BURLINGTON DEVELOPMENT REVIEW BOARD

TO: Development Review Board
FROM: Scott Gustin 
DATE: September 2, 2014
RE: 14-1320CA; 10 University Place

Request: Demolition of Chittenden, Buckham, Wills residential complex with redevelopment plans including Green Mountain walkway and associated pedestrian amenities. Construction of a replacement parking area is also included.

LI-1.0

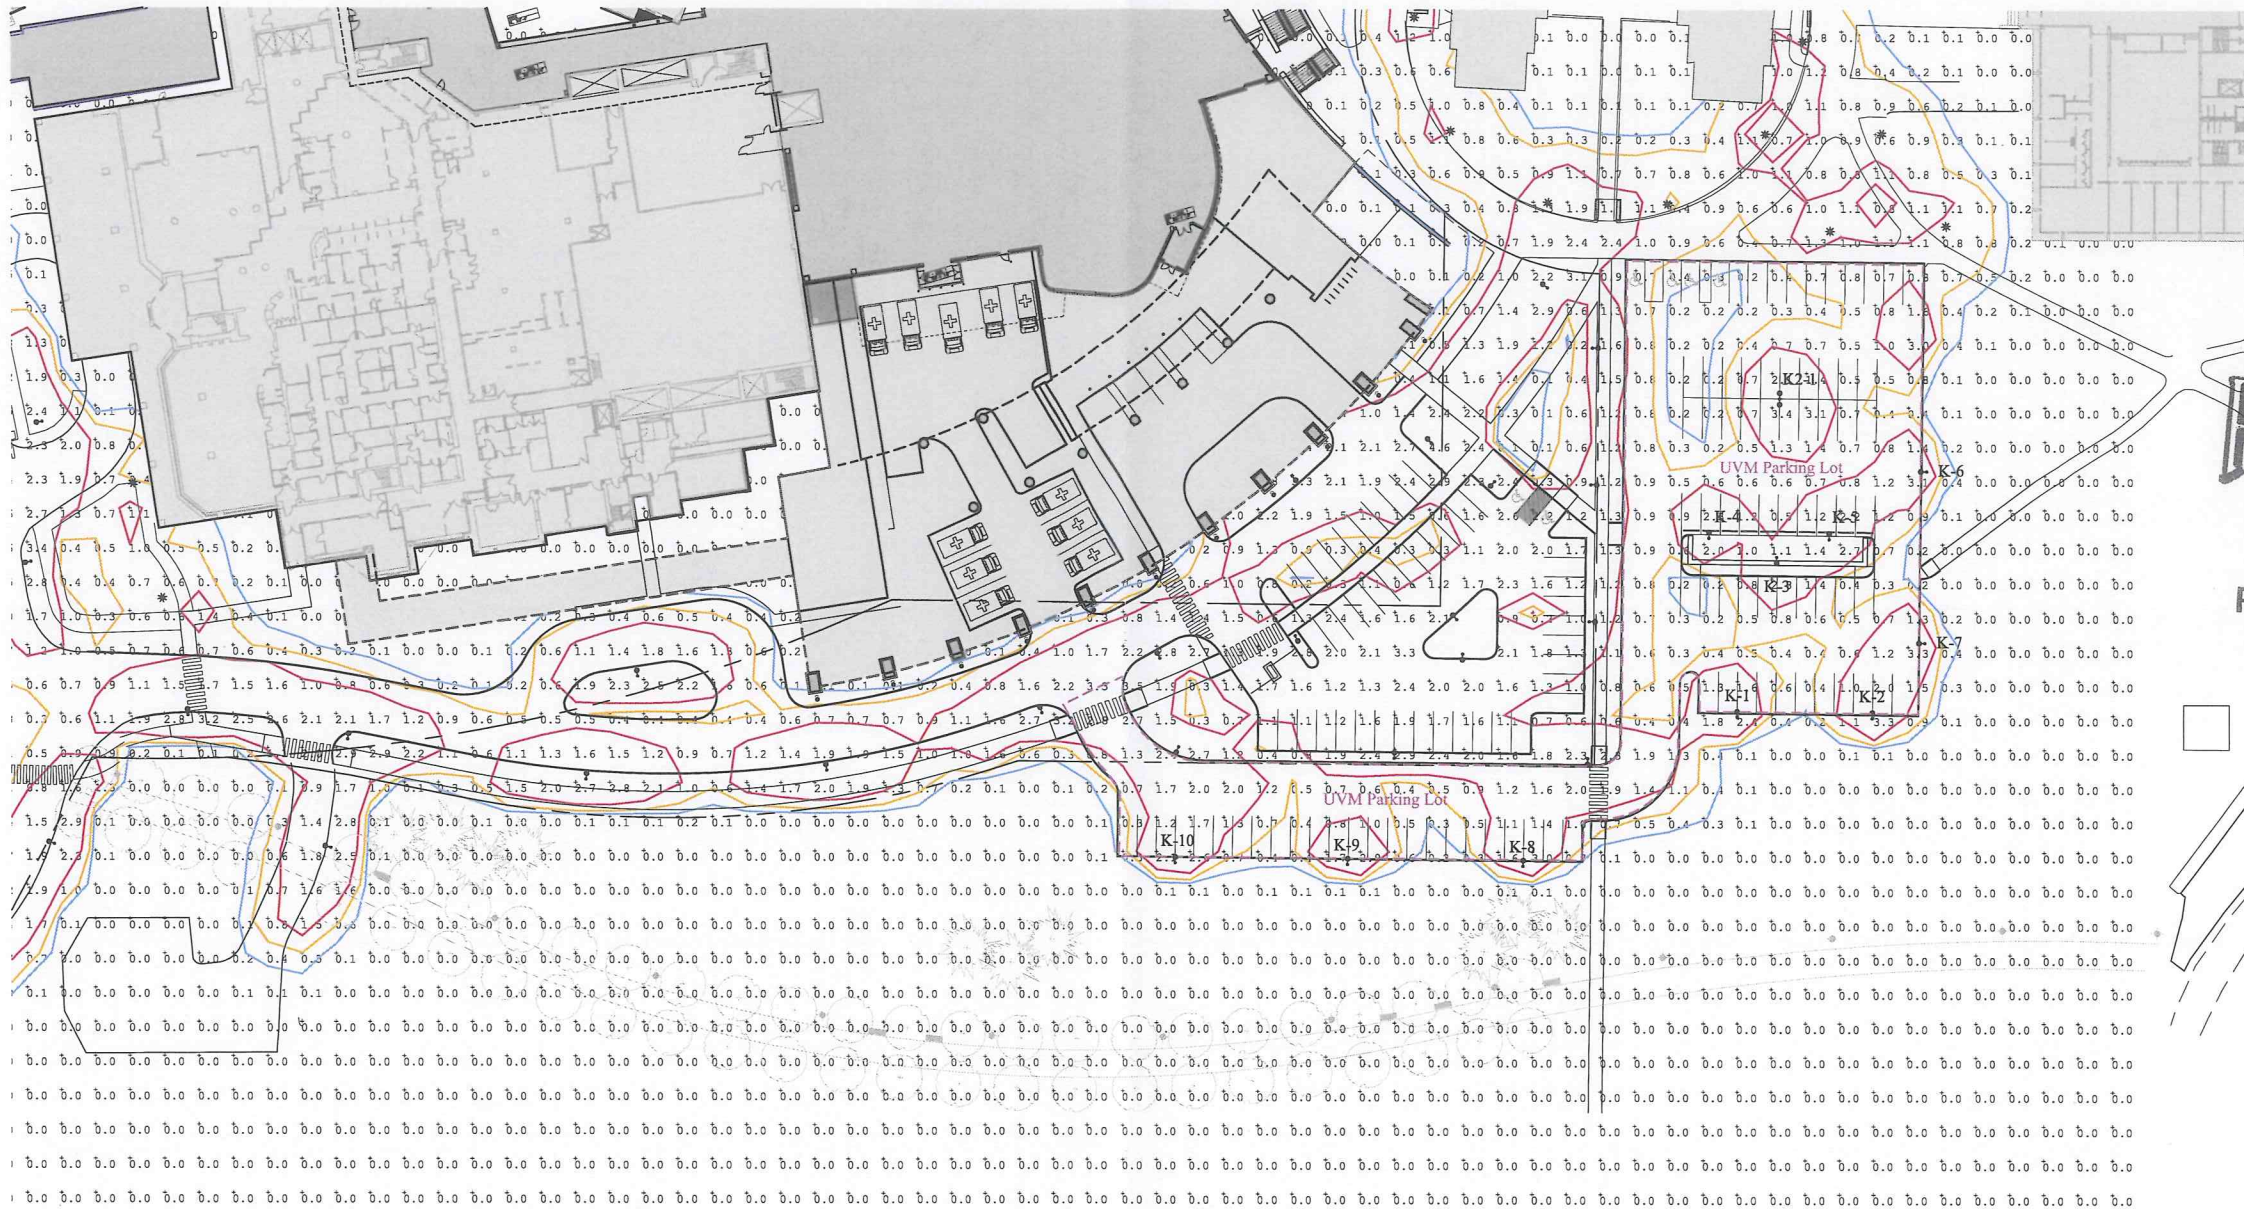
Plan LI-1.0 (photometric) reveals light levels that exceed this standard, particularly at the base of fixtures C2-1, C2-2, C2-3, and C11. These light levels will need to be adjusted to meet this standard.

On the same plan, the uniformity ratio for the FAHC parking lot is 52:00; exceeding this standard. Again, light levels will need to be adjusted to meet this standard.
